<b>Docket Number:</b>	11-AFC-04
<b>Project Title:</b>	Rio Mesa Solar Electric
<b>TN #:</b>	233558
<b>Document Title:</b>	Applicant's Supplemental Response to Data Request 16 and 26 Additional Information Regarding Cumulative Impacts
<b>Description:</b>	N/A
<b>Filer:</b>	Marichka Haws
<b>Organization:</b>	California Energy Commission
<b>Submitter Role:</b>	Commission Staff
<b>Submission Date:</b>	6/19/2020 3:18:11 PM
<b>Docketed Date:</b>	6/19/2020

## **APPLICANT'S SUPPLEMENTAL RESPONSE TO DATA REQUEST 16 AND 26: ADDITIONAL INFORMATION REGARDING CUMULATIVE IMPACTS**

**BLM RENEWABLE ENERGY APPLICATIONS IN THE PROJECT VICINITY**  
**RIO MESA SOLAR ELECTRIC GENERATING FACILITY**  
**RIVERSIDE COUNTY, CALIFORNIA**

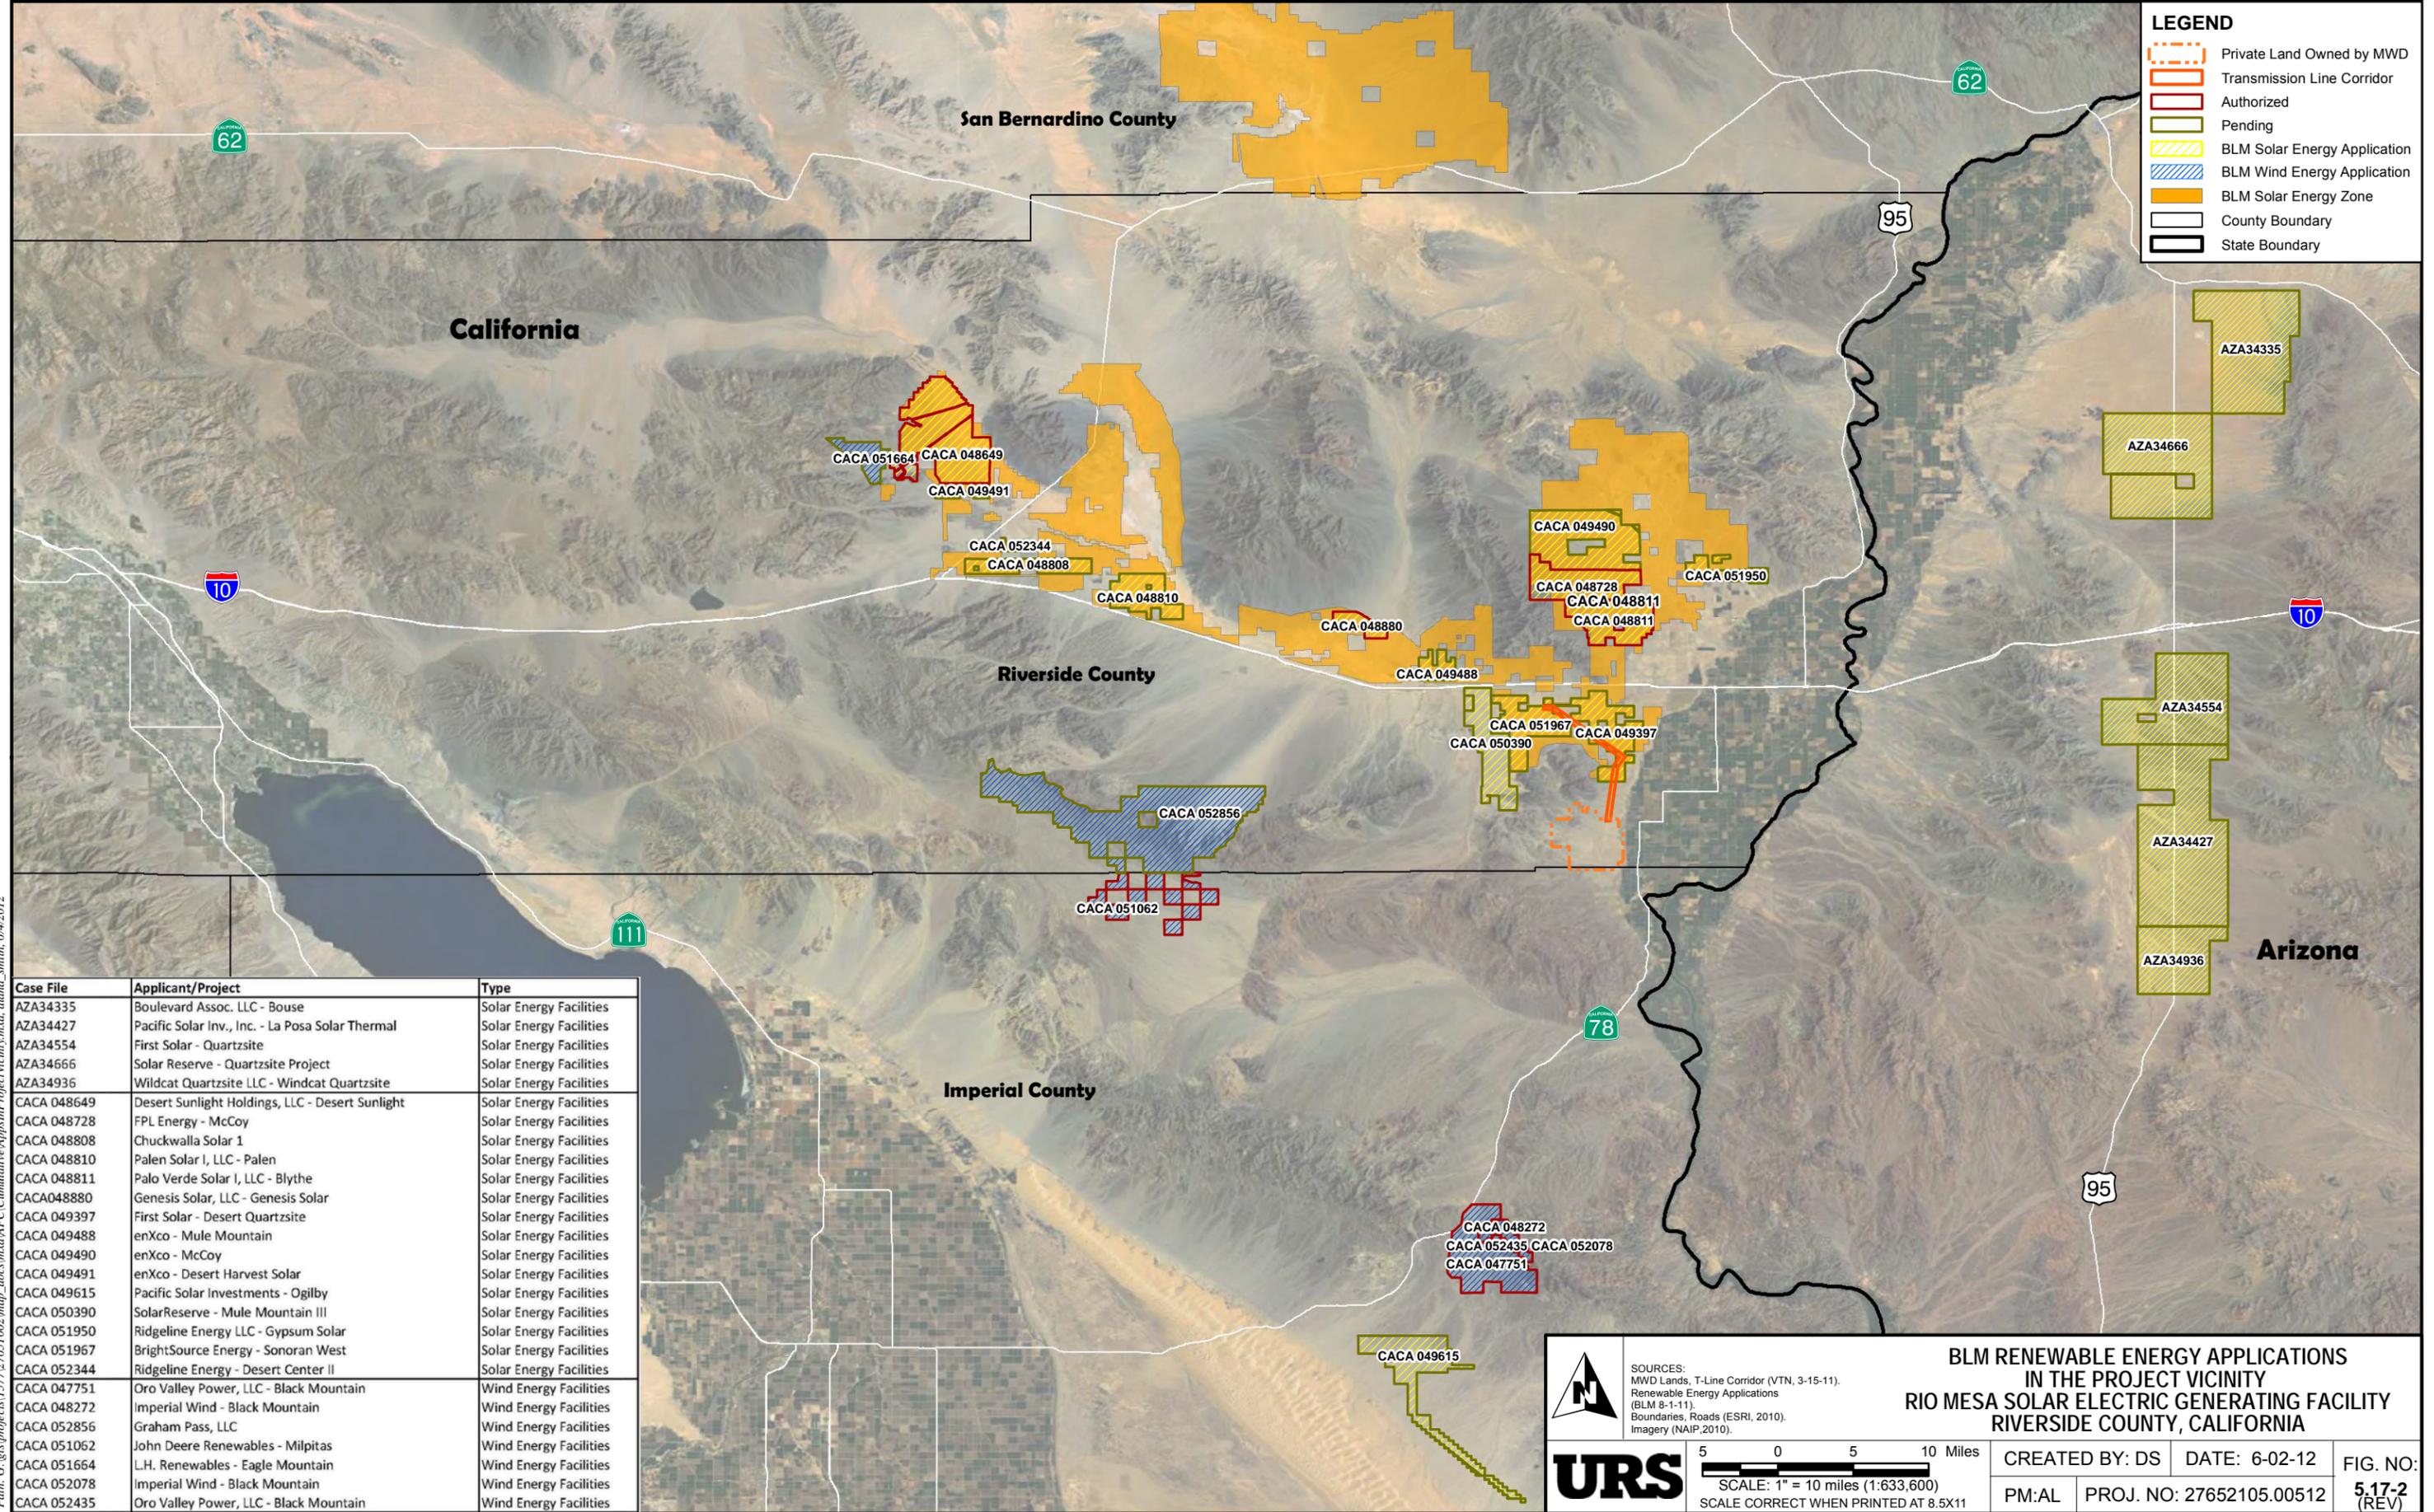
Figure 5.17-1	BLM Renewable Energy Applications in the California Desert Conservation Area
Figure 5.17-2 <a href="#">(rev)</a>	BLM Renewable Energy Applications in the Project Vicinity
